# PLANNING AND ZONING CASE CHECKLIST

P&Z CASE # SP2019-043 P&Z DATE 12/30/19 CC DATE \_\_\_\_\_ APPROVED/DENIED \_\_\_\_\_  
ARCHITECTURAL REVIEW BOARD DATE \_\_\_\_\_ HPAB DATE \_\_\_\_\_ PARK BOARD DATE \_\_\_\_\_

Date: 2019-12-13 Job Number: 2019-001  
 Project Name: Ranch Trail Office Park  
 Project Submittal: Amended Site Plan – SP2019-043  
 To: Korey Brooks  
Senior Planner  
City of Rockwall  
385 S. Goliad Street, 75087  
972.772.6434

Re: Ranch Trail Office Park– Amended Site Plan - SP2019-043

DATE: JAN 2019 SHEET NO.:  
 PROJECT NO.: 2019001  
 DRAWN BY: A502  
 CHECKED BY:

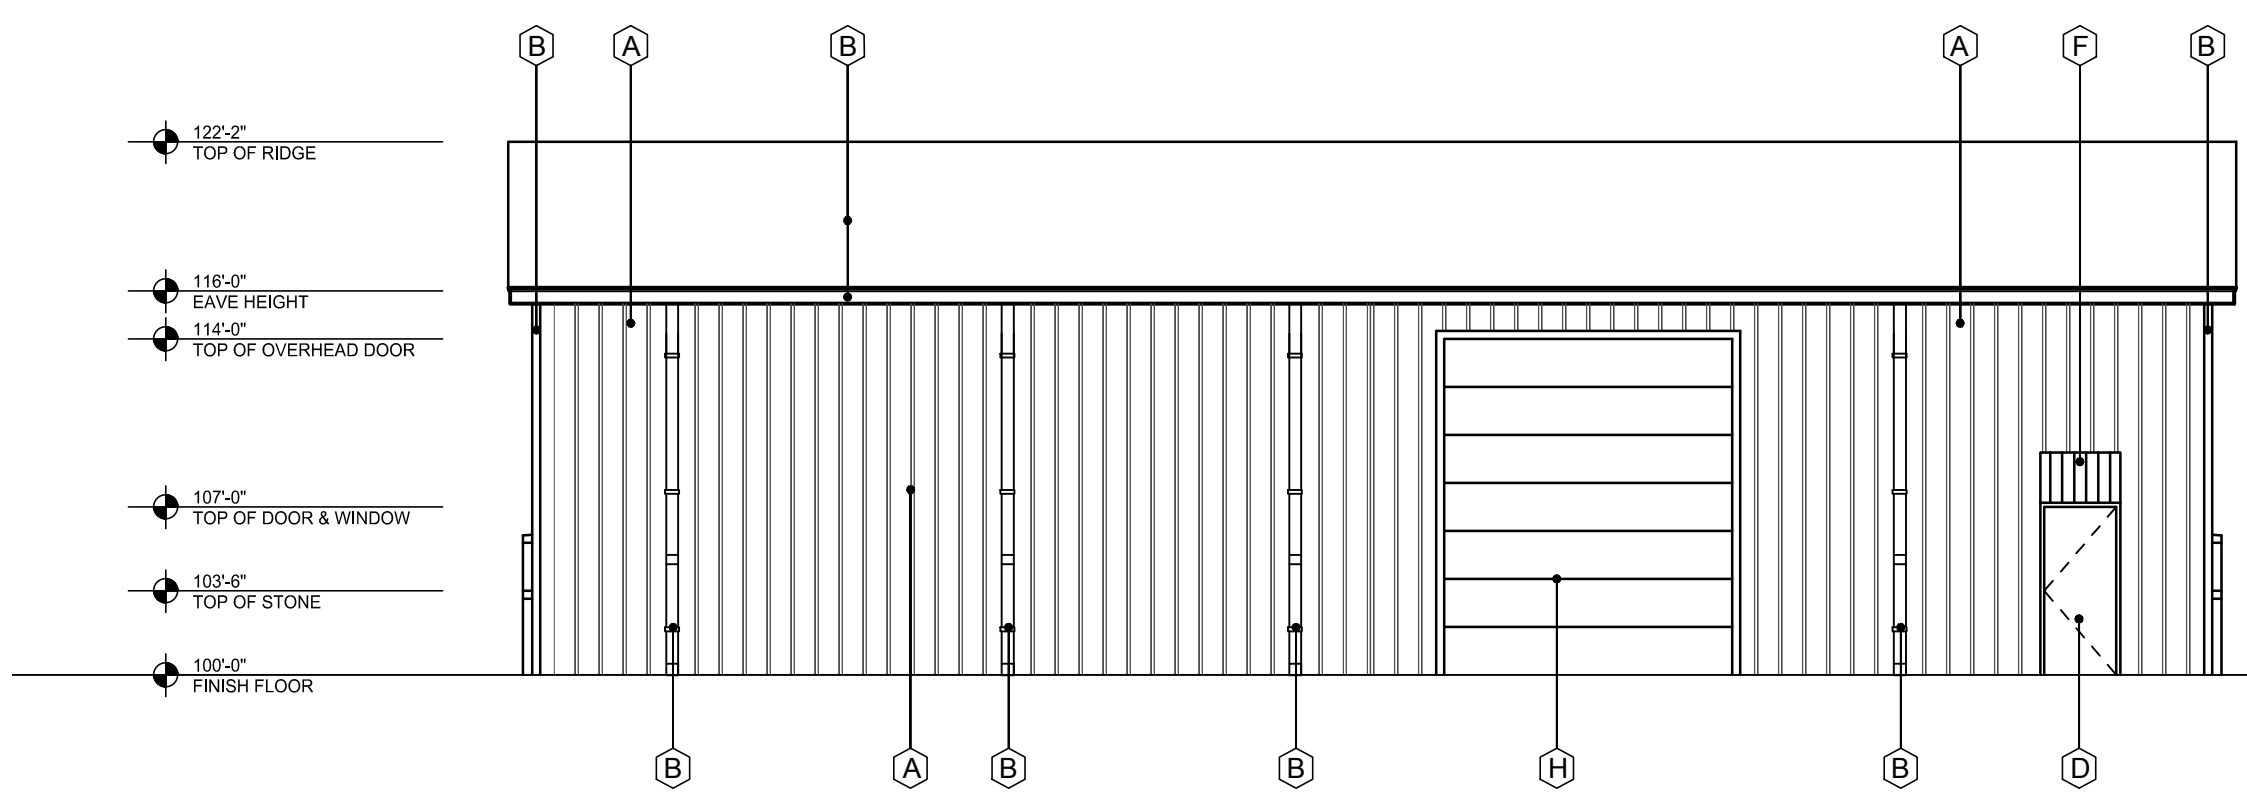
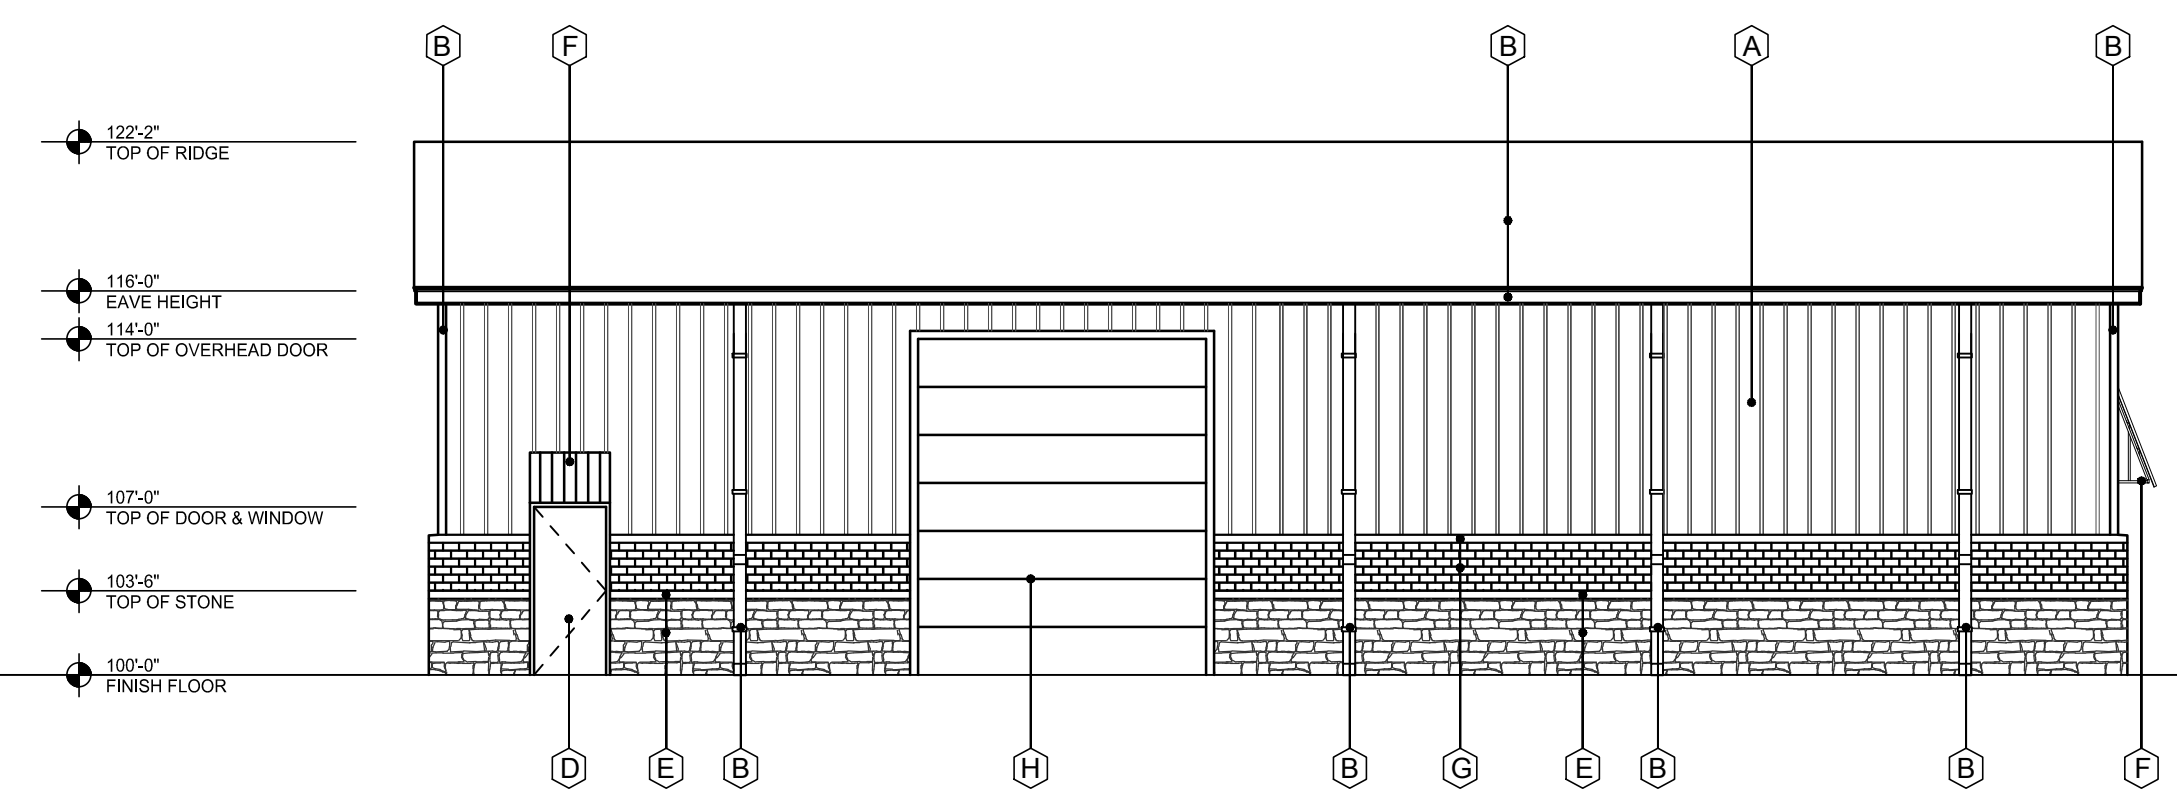
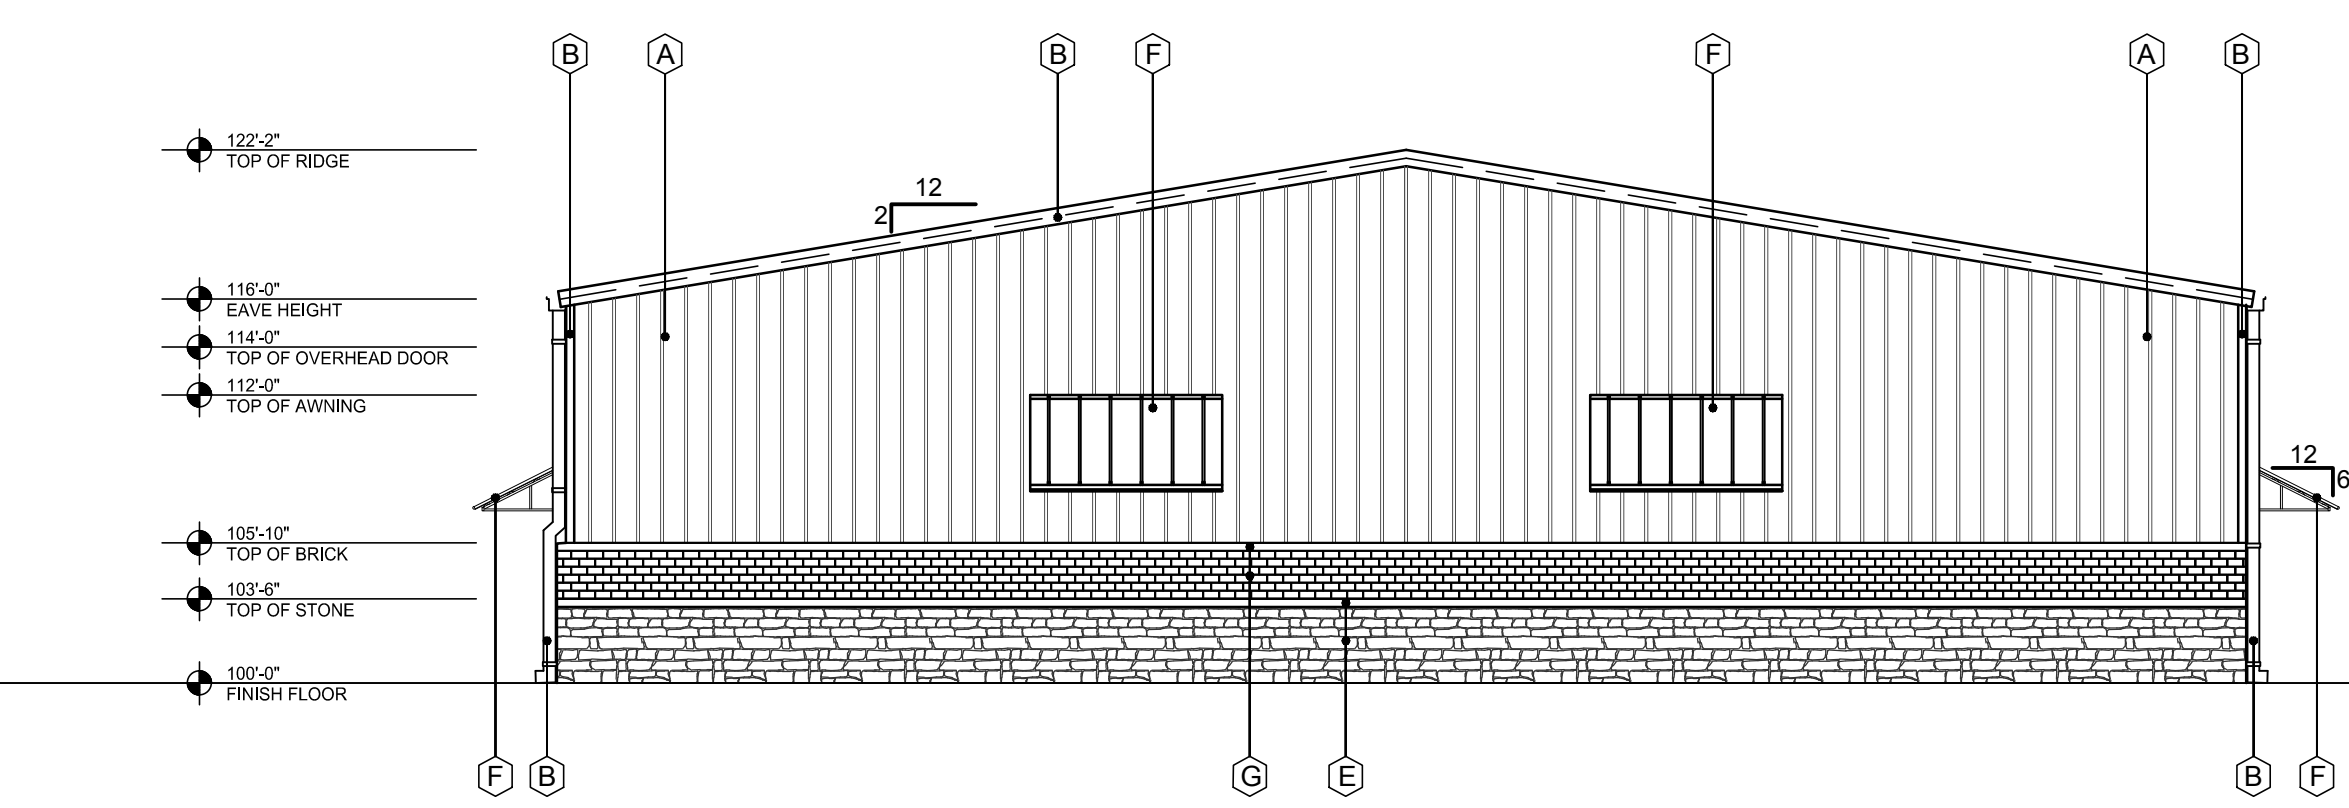
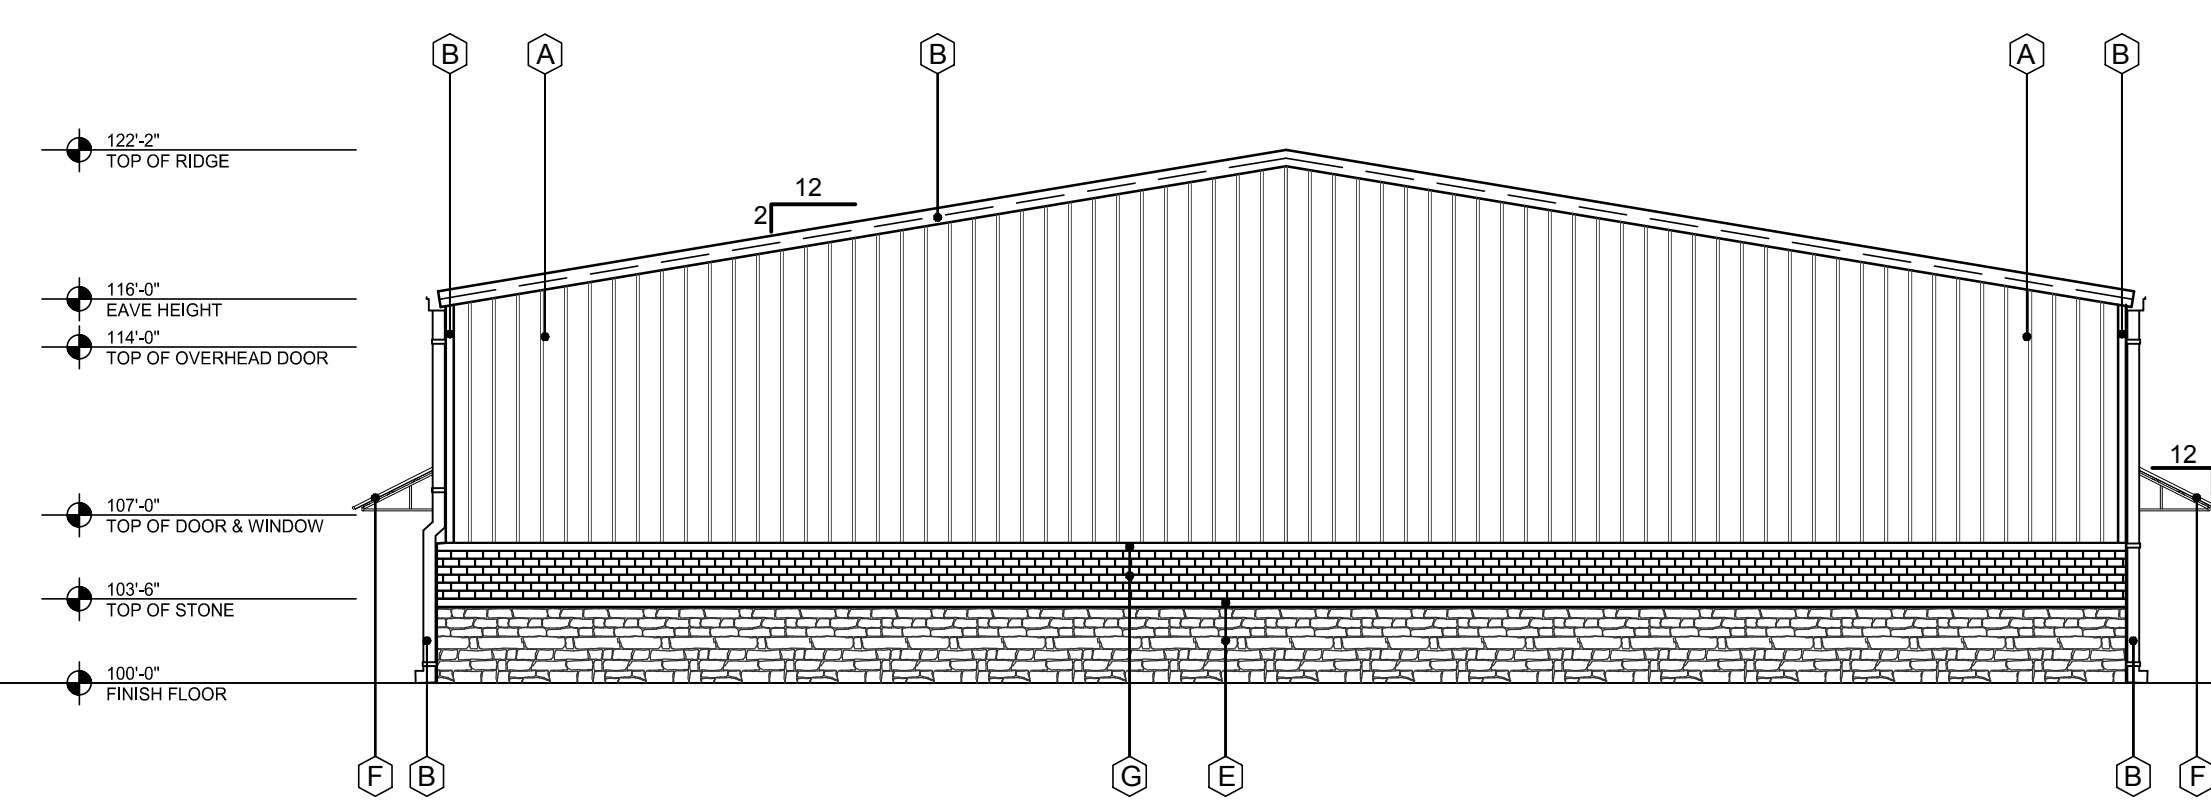
33. Building Elevations. Please provide updated drawings showing the proposed wainscot and material percentages.

34. Building Elevations. Please provide building elevation for each building type. Please note, as drawn, a variance to the building articulation standards is required. See standard below.

***BUILDING ELEVATIONS HAVE BEEN REVISED.***

**6 DUMPSTER ELEVATION**  
SCALE: 1/4"=1'-0"

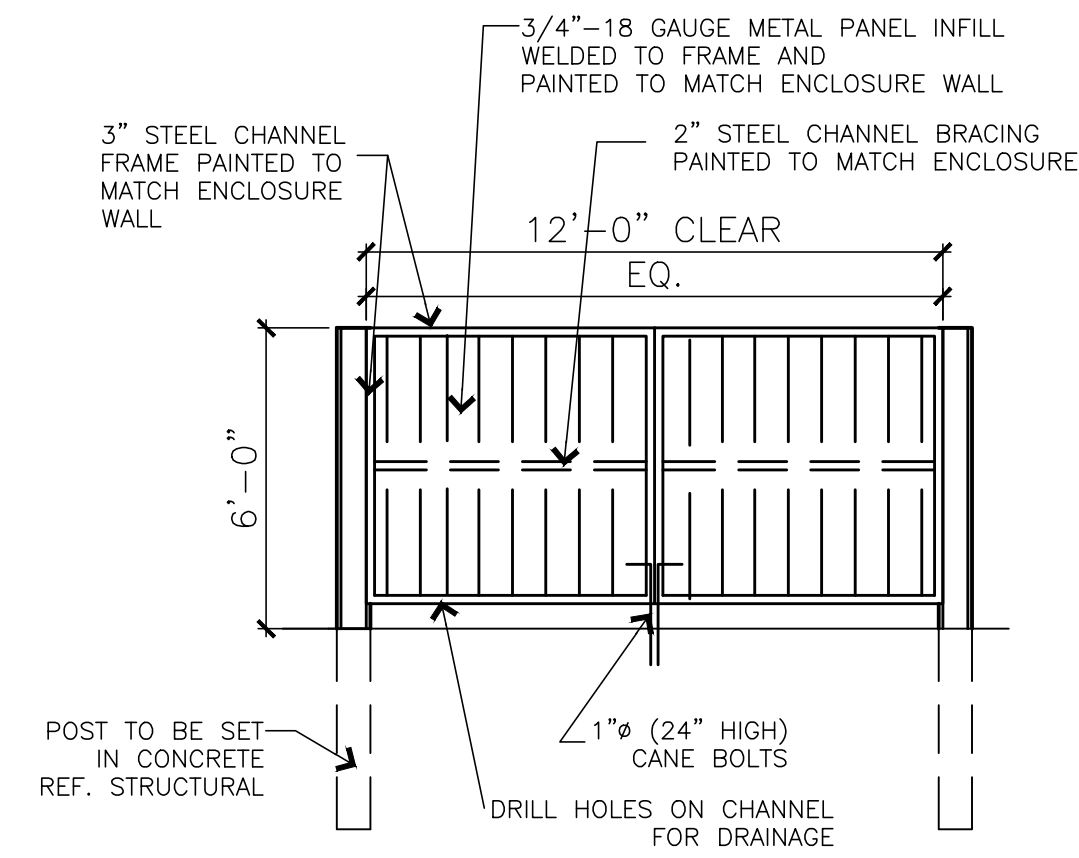
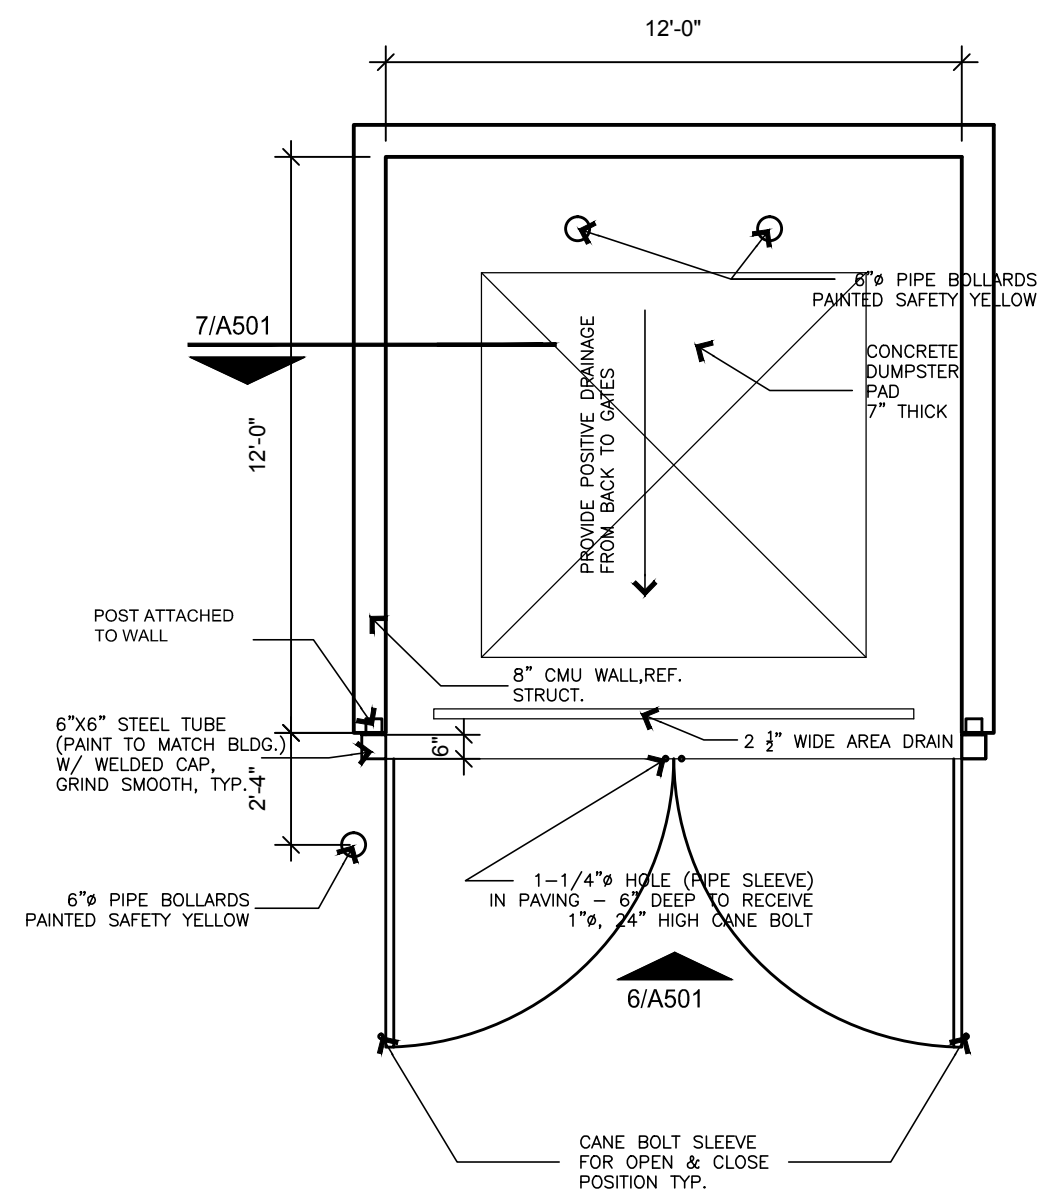
36. Building Elevation. Please provide elevation for dumpster enclosures.
